Project	IEEE 802.16 Broadband Wireless Access Working Group < http://ieee802.org/16 >	
Title	Simplification of downlink STC in PUSC	
Date Submitted	2005-01-24	
Source(s)	Yuval Lomnitz Dov Andelman Intel.	Yuval.Lomnitz@intel.com
	Yossi Segal Yigal Leiba Runcom Ltd.	
	Ran Yaniv Alvarion Ltd.	
Re:	IEEE P802.16REVd/D5-2004	
Abstract	Corrections and clarifications of definitions for STC in OFDMA PHY.	
Purpose	Adopt changes.	
Notice	This document has been prepared to assist IEEE 802.16. It is offered as a basis for discussion and is not binding on the contributing individual(s) or organization(s). The material in this document is subject to change in form and content after further study. The contributor(s) reserve(s) the right to add, amend or withdraw material contained herein.	
Release	The contributor grants a free, irrevocable license to the IEEE to incorporate material contained in this contribution, and any modifications thereof, in the creation of an IEEE Standards publication; to copyright in the IEEE's name any IEEE Standards publication even though it may include portions of this contribution; and at the IEEE's sole discretion to permit others to reproduce in whole or in part th

Figure 245 – Cluster structure for STC PUSC using 2 Antennas

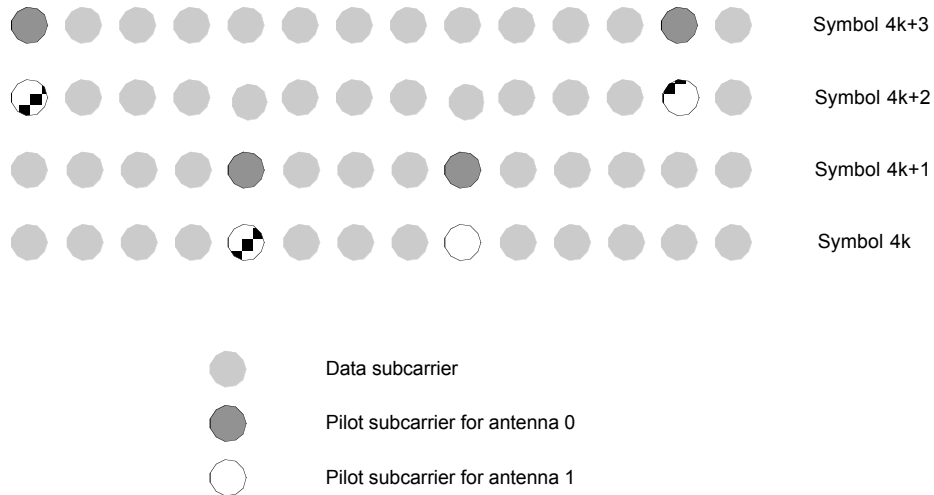
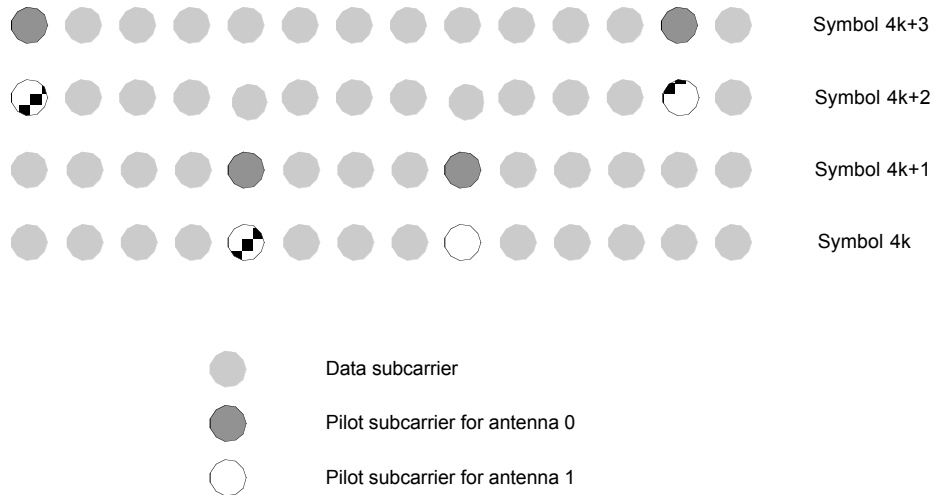
We propose that for STC in PUSC the pilot locations in the cluster will be changed as follows:

- The number of data subcarriers per cluster is constant, and therefore there is no need for additional switching between tones.
- This keeps the original PUSC permutation for odd and even symbol. The only change is to use the pilot locations of the odd symbol for two symbols, and then the even symbol for two symbols.
- The channel can be estimated from one cluster over 2 symbols, or alternatively from 4 symbols for better channel estimation. There is not additional delay because of working in 4 symbol blocks, because for the 6th symbol the channel can be estimated using symbols 2,3,4,5, etc.
- STC combining can be done on the data subcarriers in two adjacent symbols (as in FUSC).

In PUSC the data allocation to cluster is changed (Figure 245) to accommodate two antennas transmission with the same estimation capabilities, each cluster shall be transmitted from each antenna.

Figure 245 replaces Figure 234 in the definition of PUSC permutation when STC is enabled. The pilot locations change in period of 4 symbols.

STC encoding is performed on the two symbols of the PUSC slot (Each even symbol with following odd symbol).

Figure 245 – Cluster structure for STC PUSC using 4 Antennas

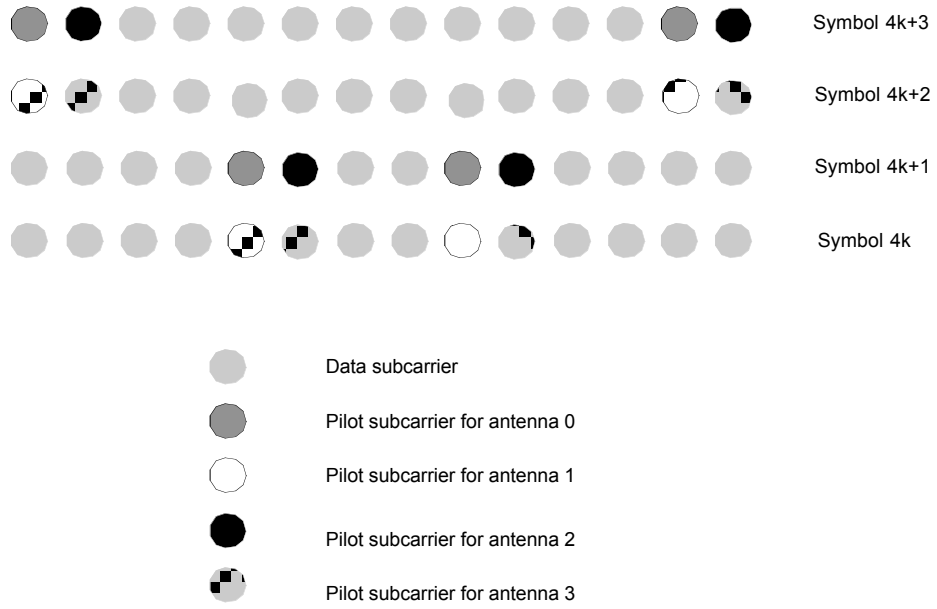
To ~~accommodate~~ **accommodate** the transmission from 4 antennas (pilots for antennas 2/3 override data subcarriers ~~in the even symbols~~, switching and erasing of the data subcarriers shall be performed after constellation mapping, ~~therefore~~ **therefore** maintaining all the encoding scheme and the subchannel allocation scheme).

[Replace figure 251]
